ADDENDUM

Re Addendum No. 1 to the Bidding Documents for:

USM
Central Heat Plant Boiler Upgrade
Portland, ME
Project No. 14411

SKA01

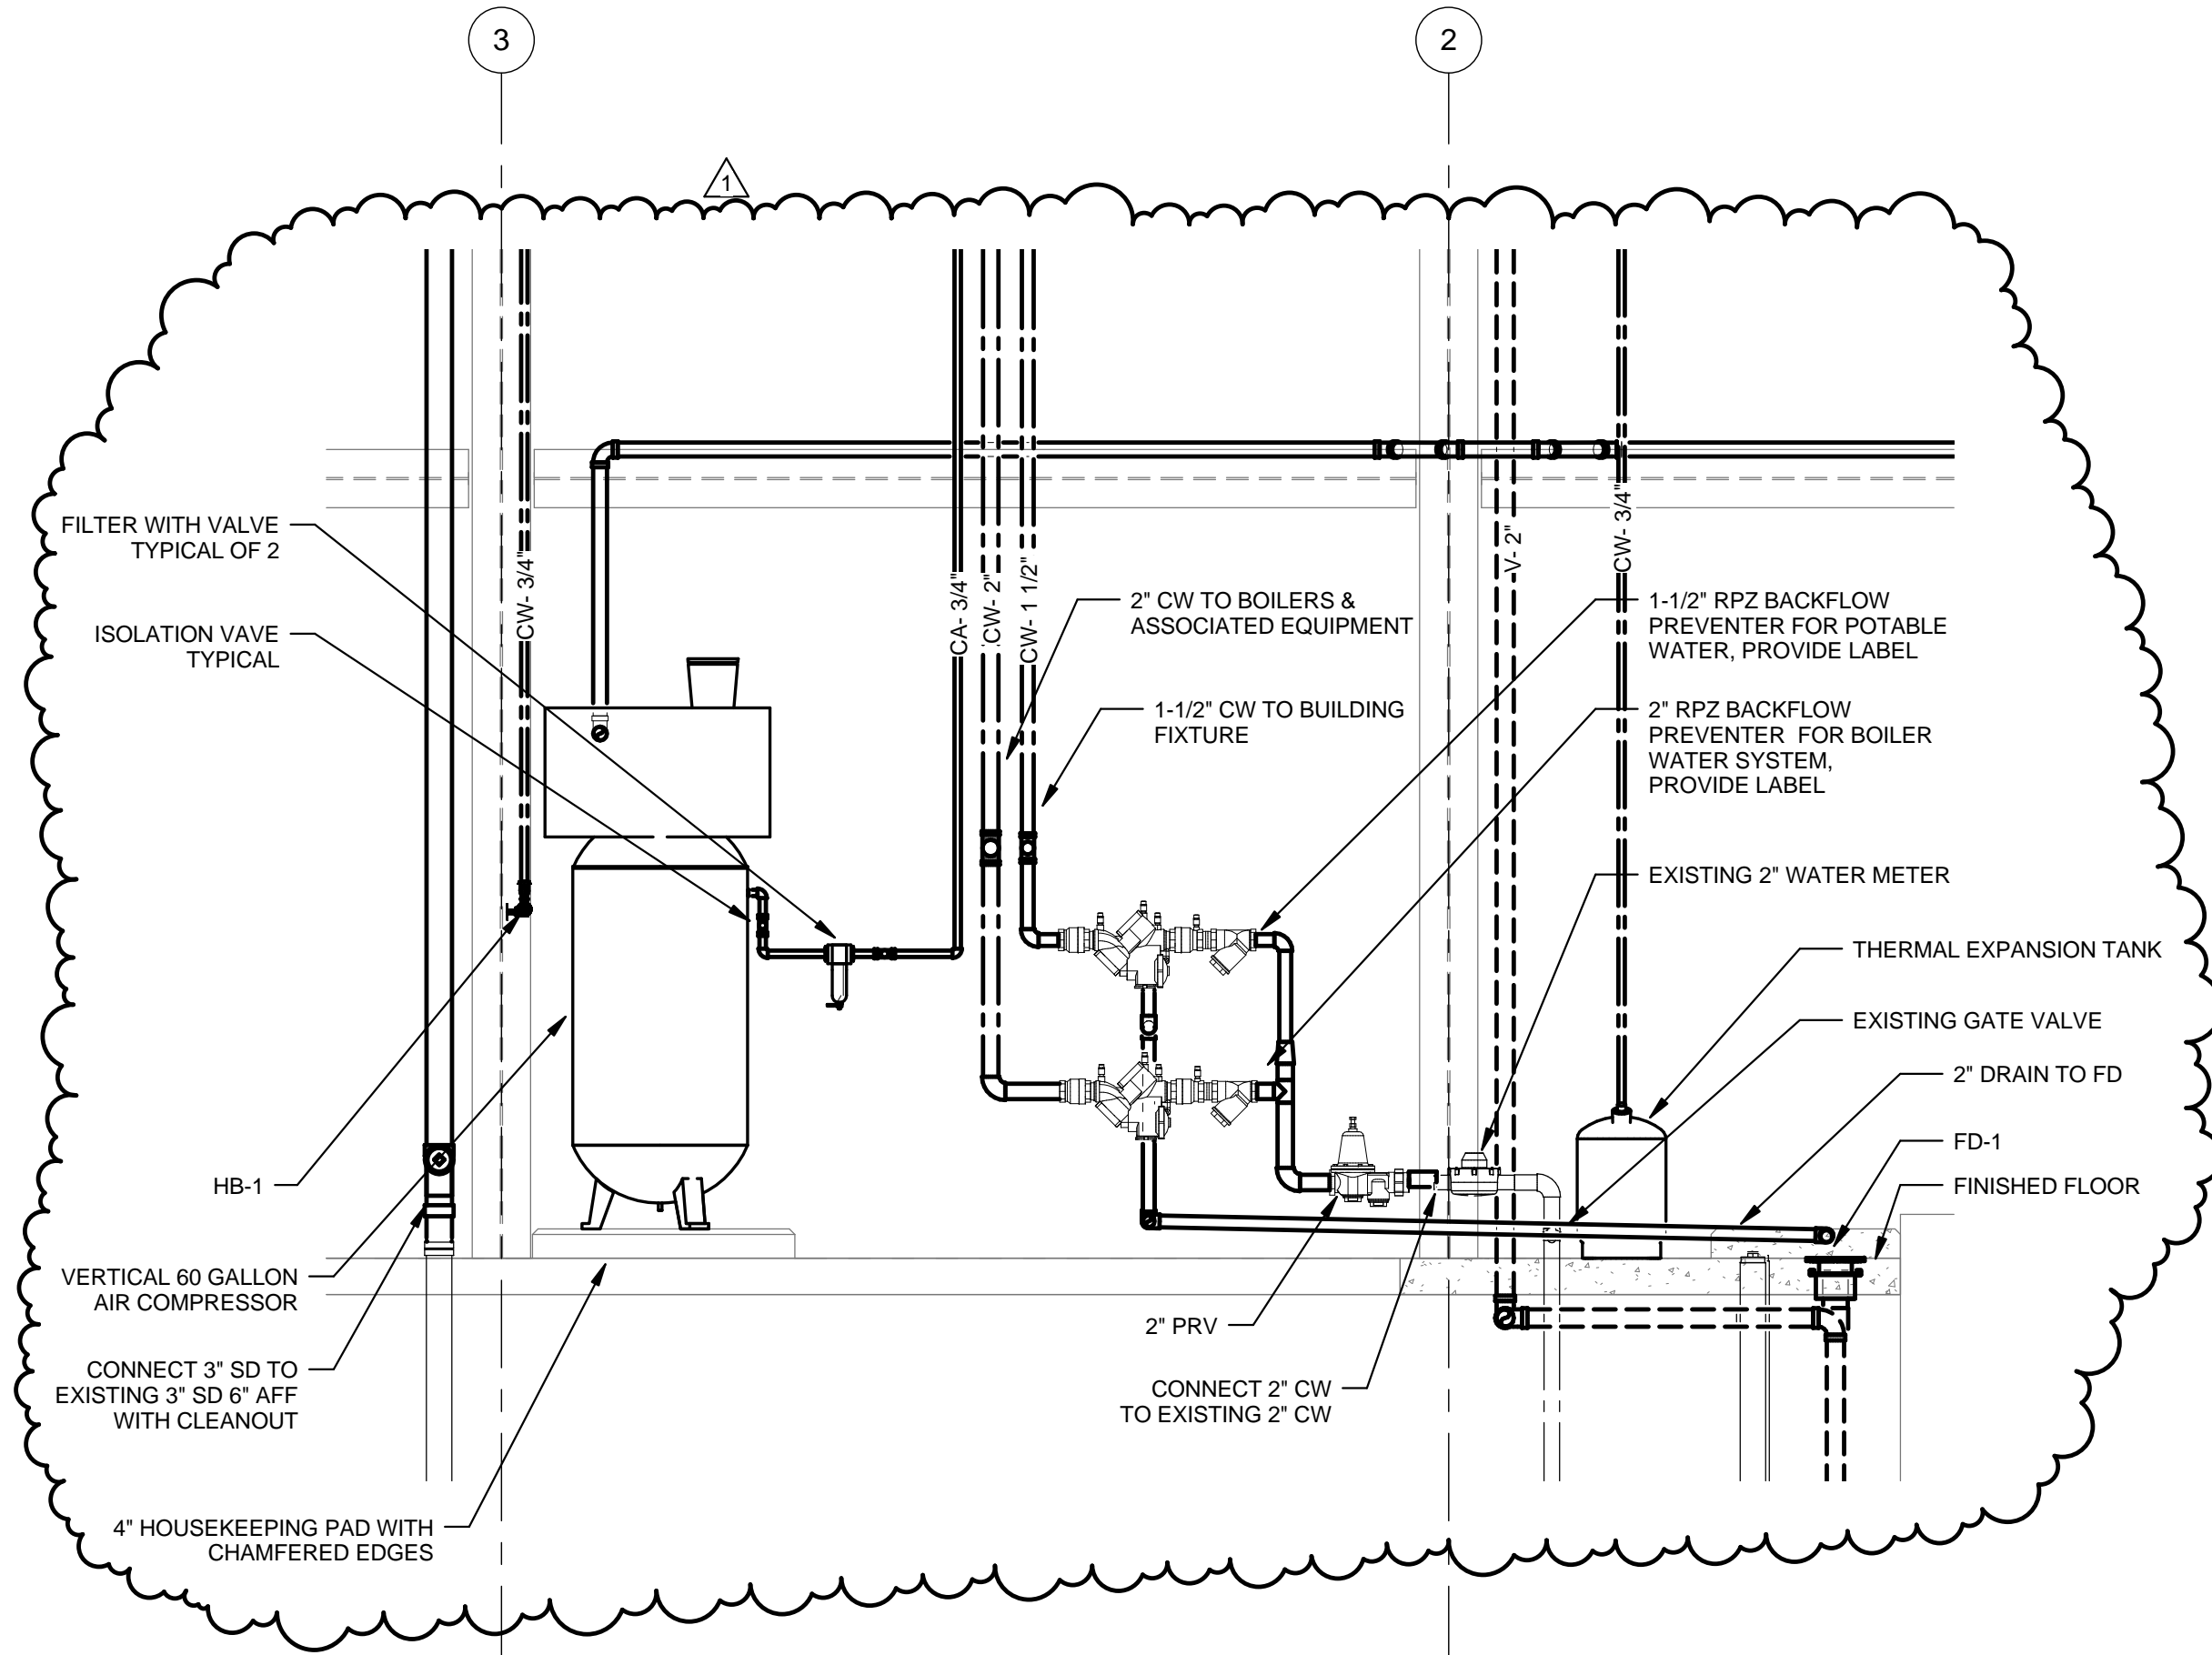
- a. General Notes – Add the following notes:
 - “6. At the Contractor’s option, John Dwyer with F.W. Webb Company (207) 541-3551 can be contacted to obtain a price to fabricate the flash tank detailed on drawing P00.1.”
- b. Delete Detail 1 and replace with sketch SKA01.
